## --- ADDENDUM #3 ---

Issued September 3, 2024 to all bidders

# Wolfville AT Connection

CLIENT  
PROJECT DESCRIPTION  
**WOLFVILLE AT CONNECTION**  
WOLFVILLE, NOVA SCOTIA  
SHEET DESCRIPTION

### CONCRETE SIDEWALK ADJACENT CURB DETAIL

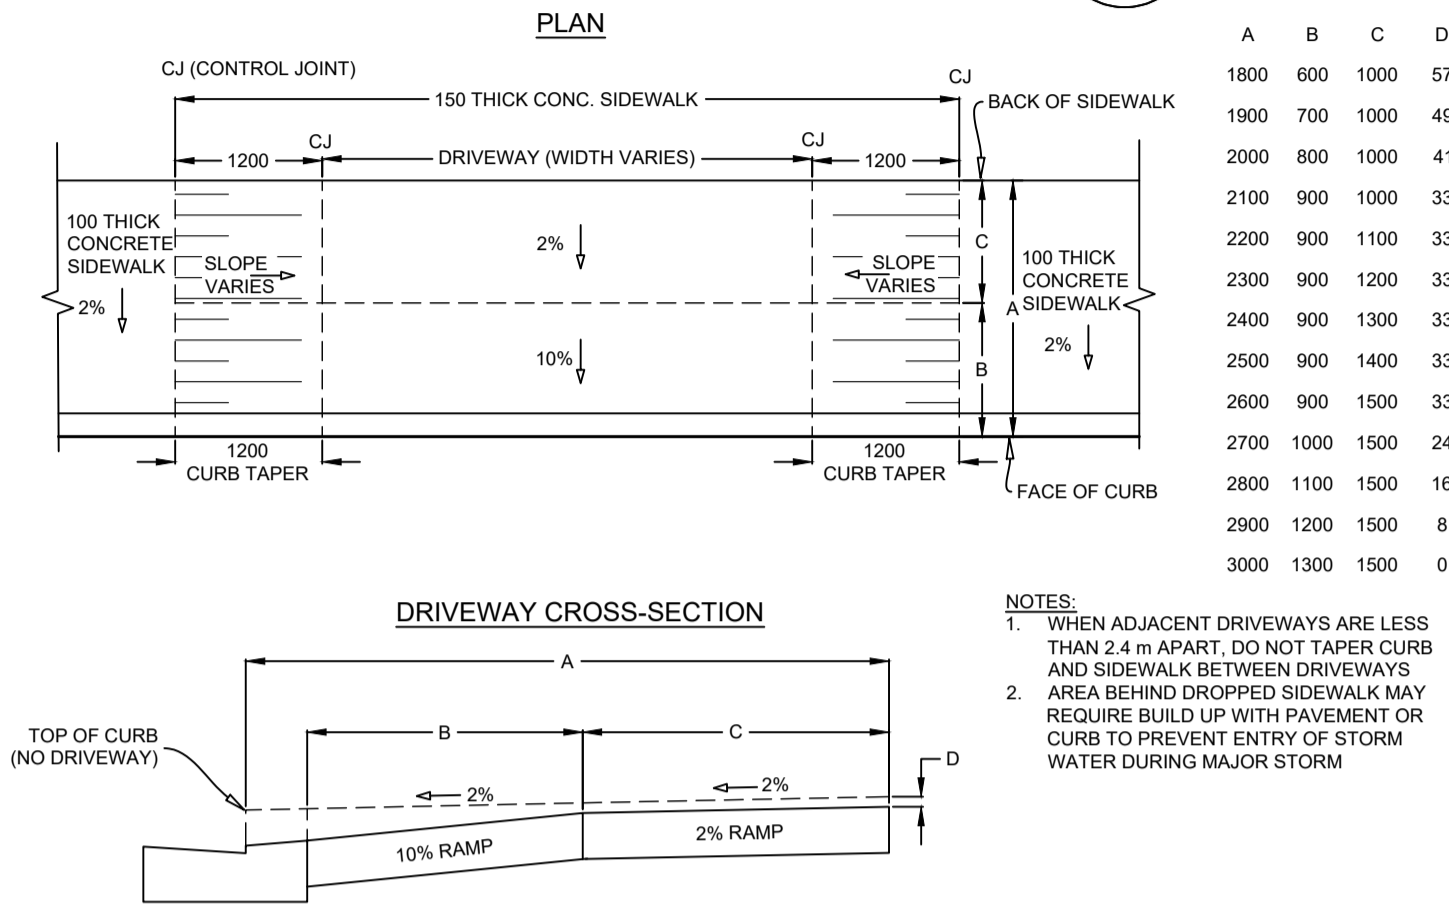
- .1 I can't seem to find a detail for the sidewalk. Please provide a detail showing the thickness of gravel required? Also, there are pay items for 150mm Concrete sidewalk and 100mm Concrete

sidewalk but nothing on the drawings shows the difference between the two. Please show on the drawings what's 100mm and what 150mm? Is welded wire mesh required in the 150mm concrete sidewalk?

**a. Detail has been added to drawing set**
